工程指示 / 要求簡箋(E.I.)

工程指示編號：EI / 5937 / 23      修改版次：  
 工程編號      : J - 858      工程名稱      : 將軍澳日出康城 11  
 工程項目      : 顧問上廠報告 (18/11-24/3) 精華版加完整版  
 收件人      : 生統 / Doris      發件人      : Paul Wong      日期      : 29/03/2023

顧問提出改善方案，請依相中指示，影回照片後放在群組 (J858 每日生產匯報群)，共 25 張。請在 4 月 10 日前交齊相，顧問和老闆在 4 月 18 日上廠看文件，請注意。

# Midi Factory Inspection on 18-Nov-2022 - Report No. R01

#1

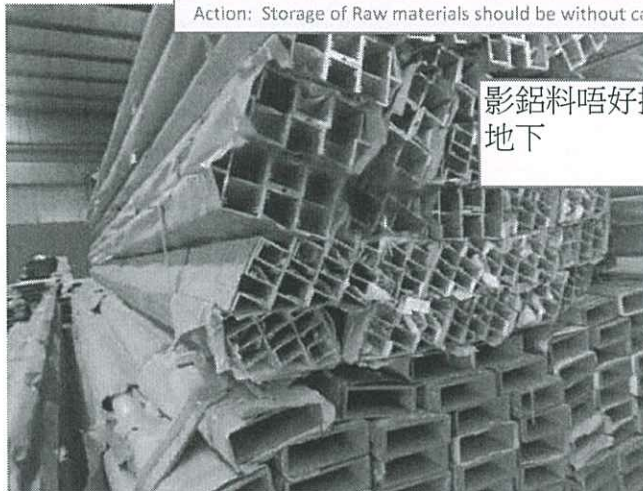
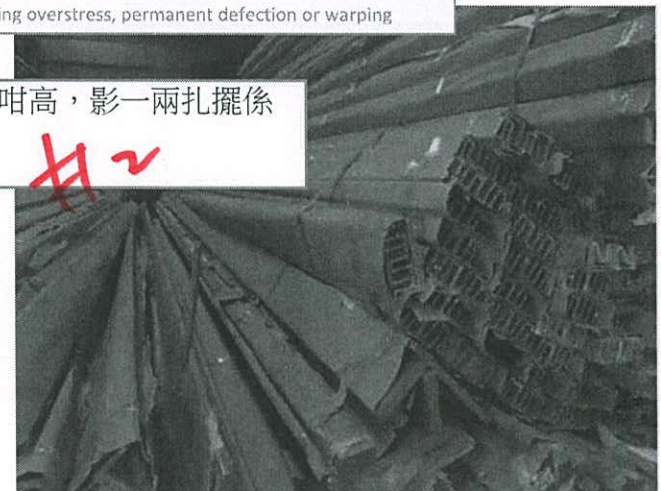
Action: Storage of Raw materials should be without causing overstress, permanent defection or warping

3\_Raw materials are in messy and heavy loading condition

Action: Storage of Raw materials should be without causing overstress, permanent defection or warping

影鋁料唔好擺咁高，影一兩扎擺係地下

影鋁料唔好擺咁高，影一兩扎擺係地下

1\_Mullion and Transom for sliding door

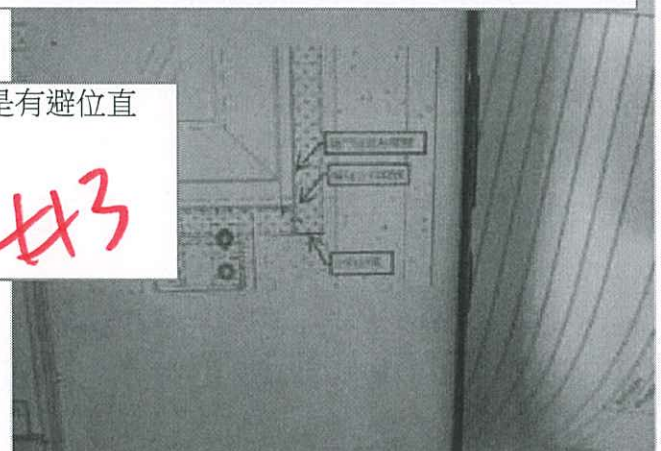
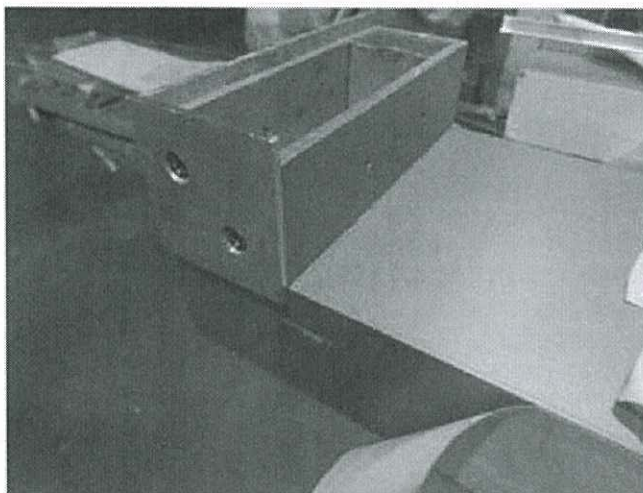
Action: Midi is required to strictly follow the agreement during tender stage for principle design to seal-up end position of Transom and Mullion

3\_ one side of mullion was found consealed

橫料同企料要跟圖組裝，是有避位直碰。要補相

23\_Blemish was observed to be existed at spandrel sealant

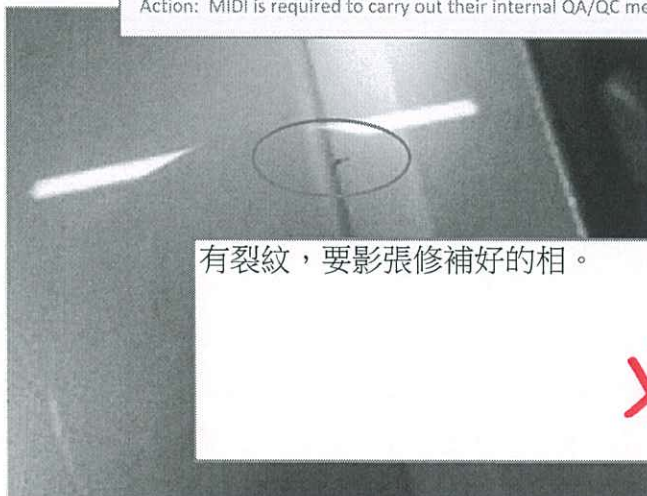
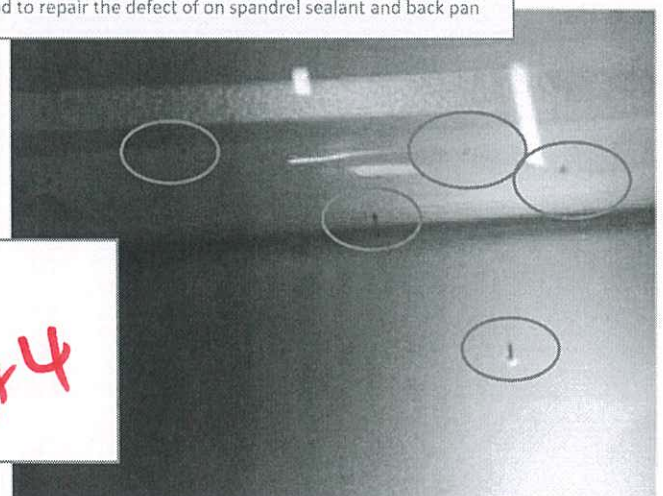
Action: MIDI is required to carry out their internal QA/QC method to repair the defect of on spandrel sealant and back pan

有裂紋，要影張修補好的相。

25\_15F-T1BCW4 AS-01 water leakage

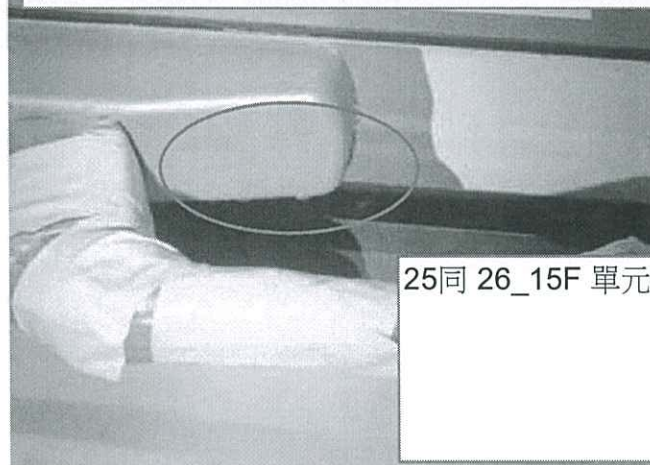
Action: MIDI is required to carry out their internal QA/QC method to repair the leakage unitized panel, MIDI needs to improve workmanship for

25同 26\_15F 單元件入水, 要補相。

Source of water leakage

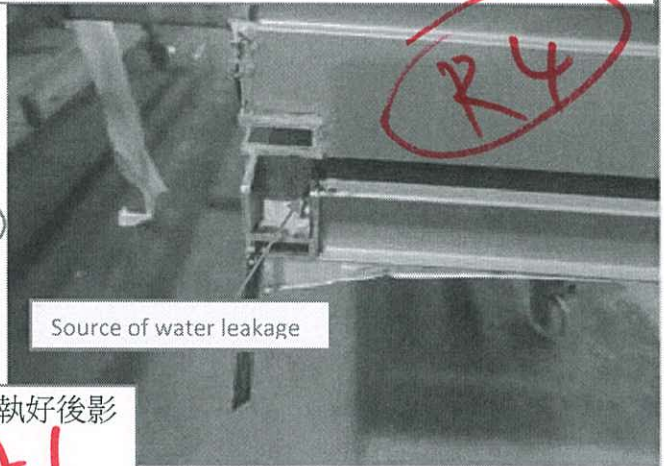
Action: MIDI is required to carry out their internal QA/QC method to repair the leakage unitized panel, MIDI needs to improve workmanship for

21\_9F\_T1BCW4\_AS0 入水, 執好後影相。

**Photo 6**

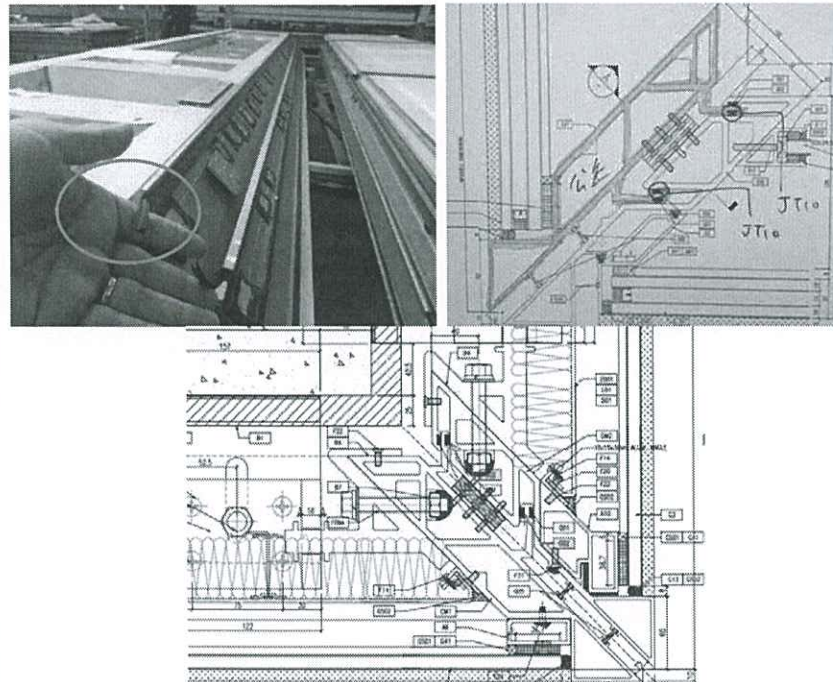
Gasket of unitized panels for Zone M01 & 02 were found not match with design drawing

-MIDI is reminded to carry out the remedial works prior products delivery and to improve workmanship for future works

影跟圖款一樣膠條相

**Photo 6**

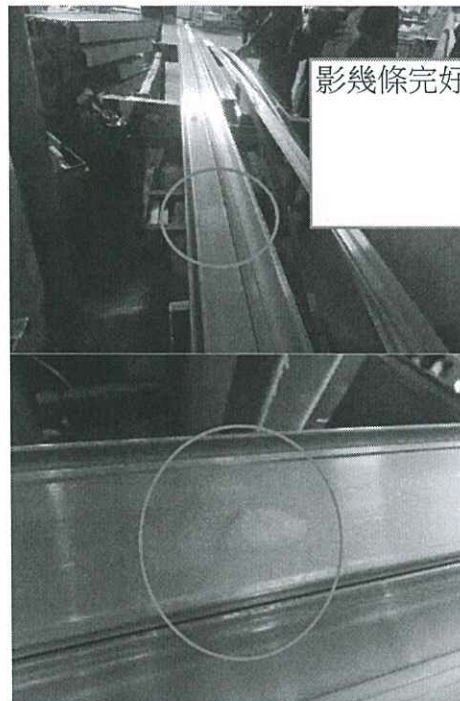
Description:  
Defective chrome plated finishing for gutter sleeve was found during factory inspection

Action:  
- MIDI is required to carry out their internal QA/QC method to repair the defective chrome plate finishing and improve workmanship for future works

影幾條完好的鉻化防水片相

**Photo 10**

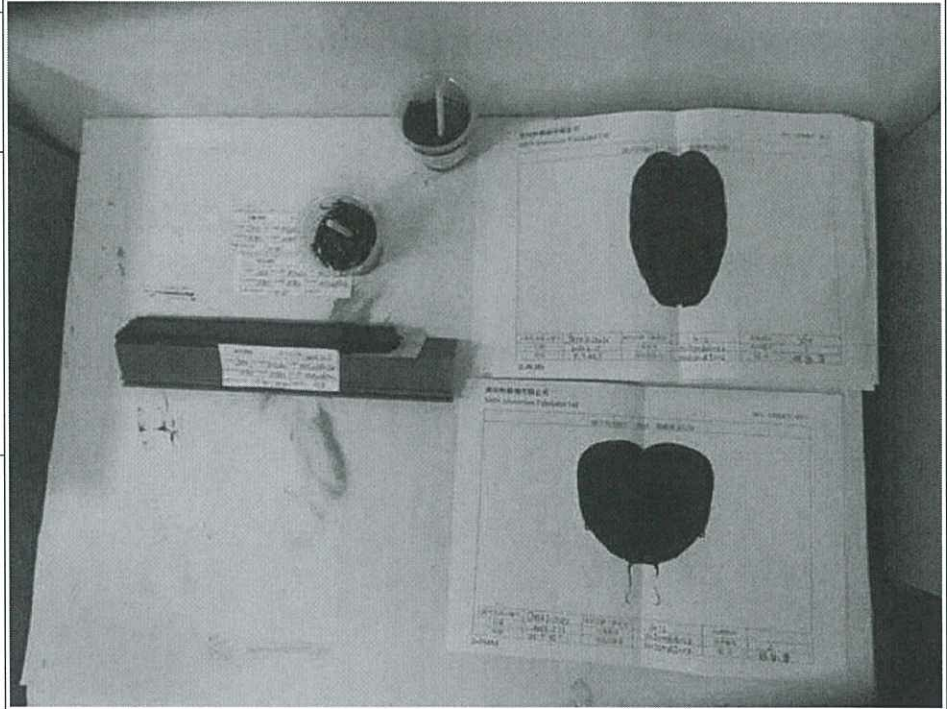
Description:  
Defective sealant for 2<sup>nd</sup>  
& 3<sup>rd</sup> log unitized panels  
were found during final  
inspection and packing

Action:  
- MIDI is reminded to  
carry out the remedial  
works prior products  
delivery and to improve  
workmanship for future  
works

影鋁通無多餘膠

啱好膠, 影相

**Photo 10**

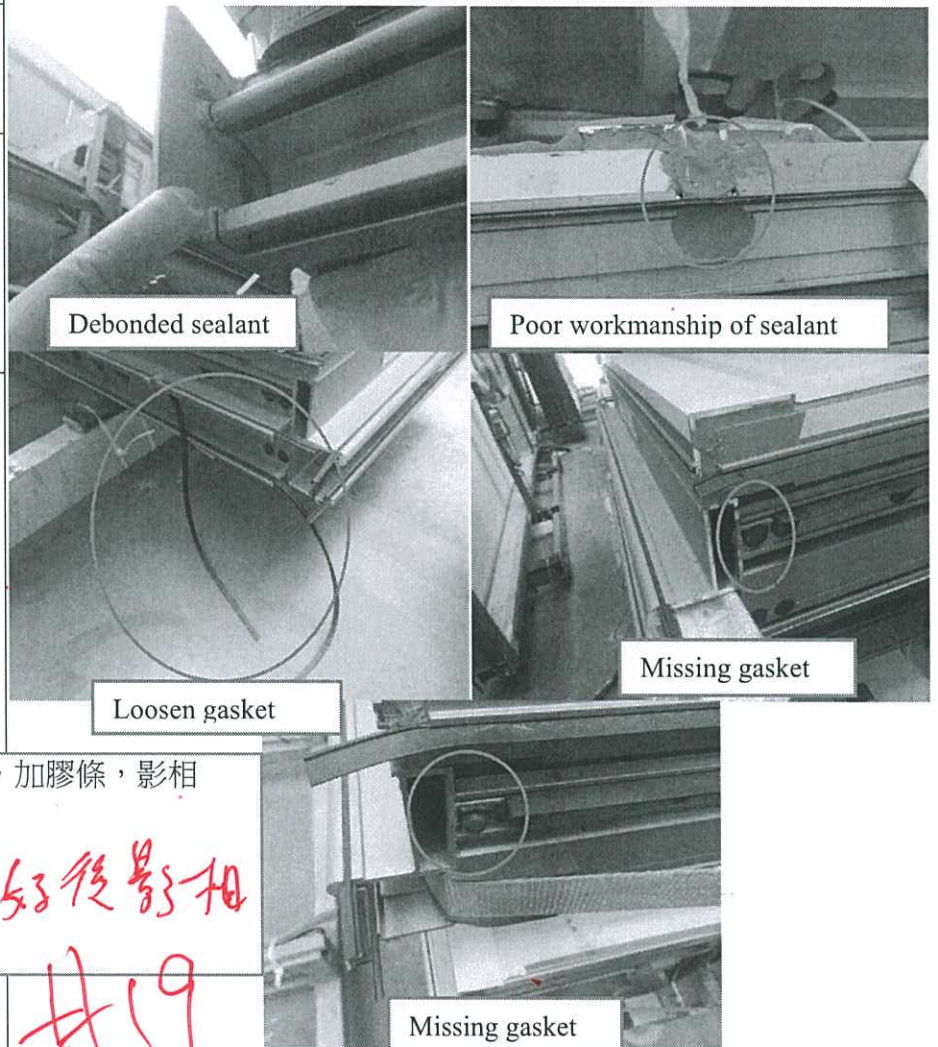
Description:  
Defective sealant and gasket for 2<sup>nd</sup> & 3<sup>rd</sup> log unitized panels were found during final inspection and packing

Action:  
- MIDI is reminded to carry out the remedial works prior products delivery and to improve workmanship for future works

啱好膠，加膠粒，加膠條，影相  
同一向畫好後影相  
詹 廿九

**Photo 10**

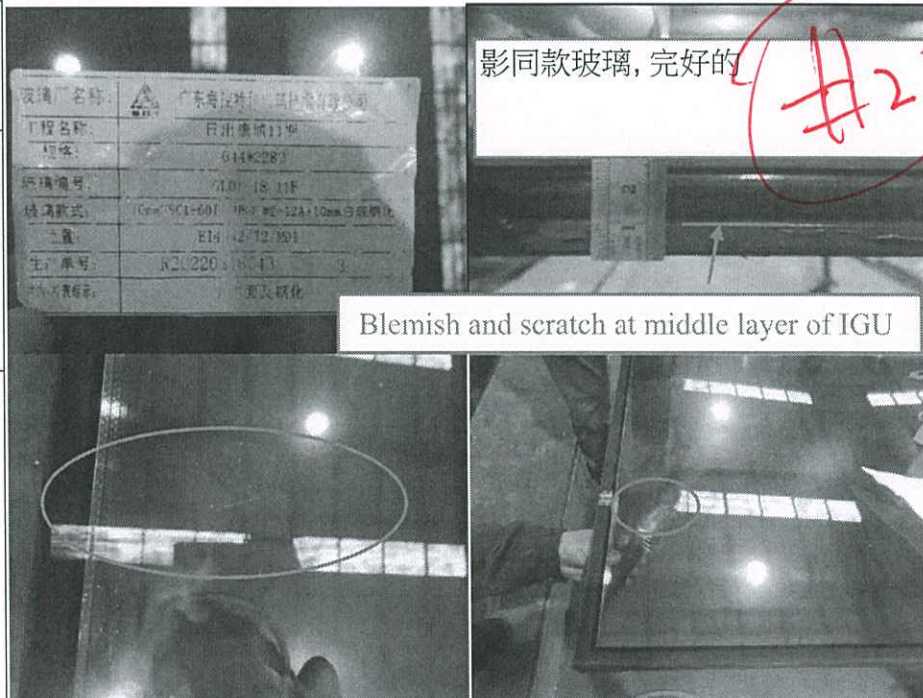
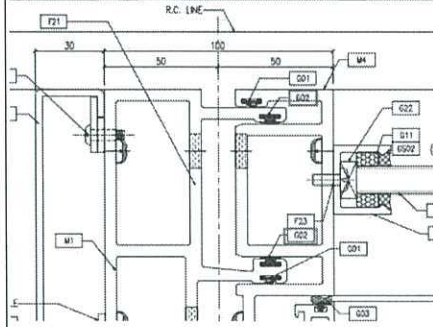
Description:  
Blemish and scratch was found at middle layer of IGU

Action:  
- MIDI is required to improve workmanship for further works

影同款玻璃, 完好的

**Photo 11**

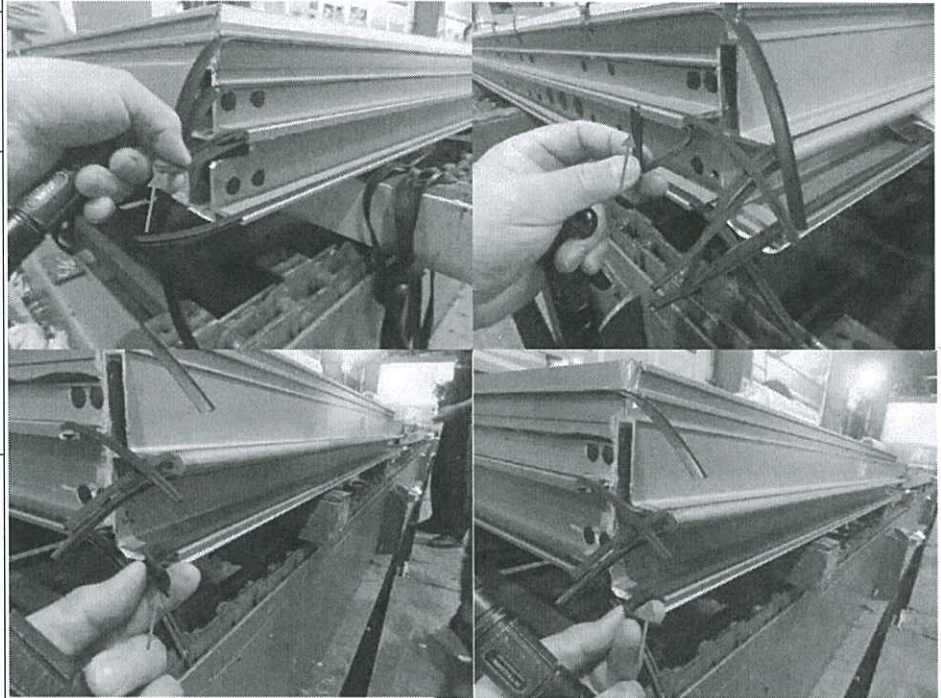
Description:  
Gasket of 2 numbers of unitized panel were found not match with design drawing during factory inspection

Action:  
- MIDI is reminded to carry out the remedial works prior products delivery and to improve workmanship for future works

更換正確的膠條, 影相  
*Handwritten signature*

**Photo 12**

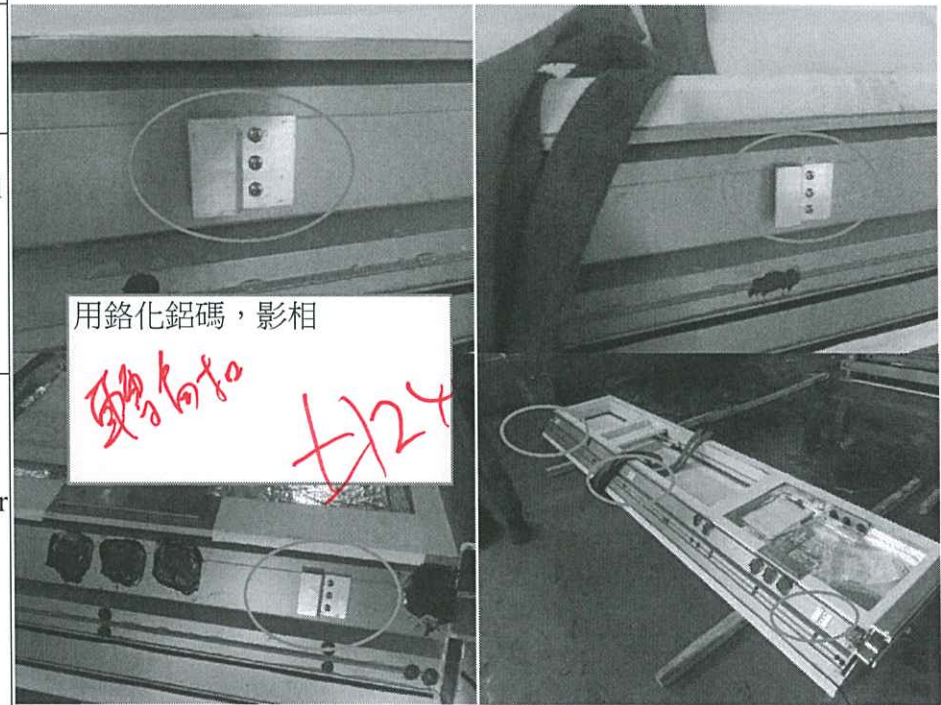
Description:  
Defective chrome plated finishing for extrusion clip was found during factory inspection

Action:  
- MIDI is required to carry out their internal QA/QC method to repair the defective chrome plate finishing and improve workmanship for future works

用鉻化鋁碼, 影相  
*Handwritten signature*

**Photo 10**

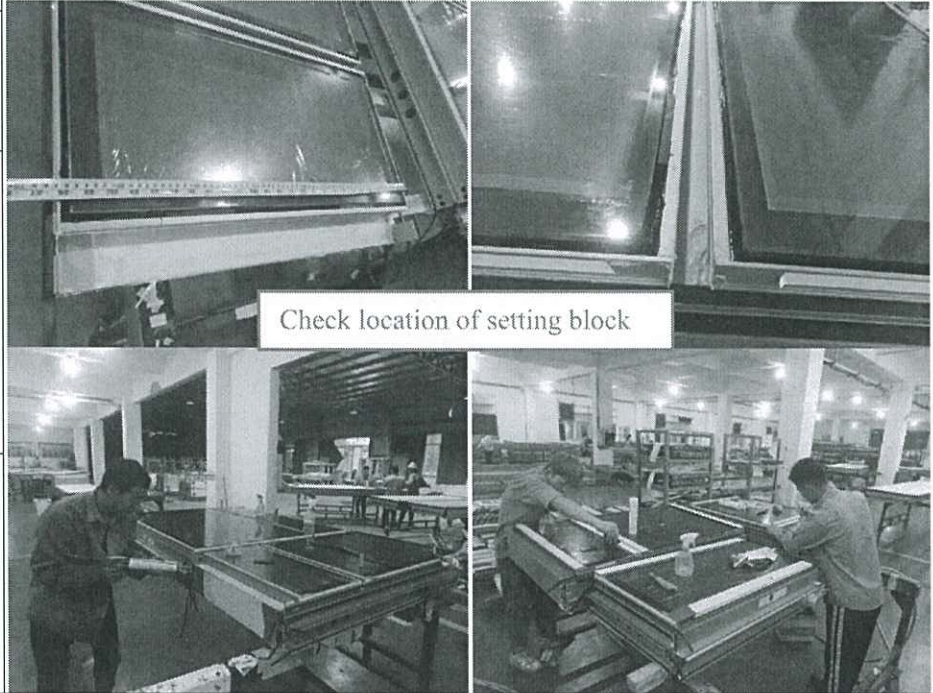
Description:  
Excessive sealant and stain was found on unitized panel surface after packing

Action:  
- MIDI is required to improve workmanship for further works

影完好框相
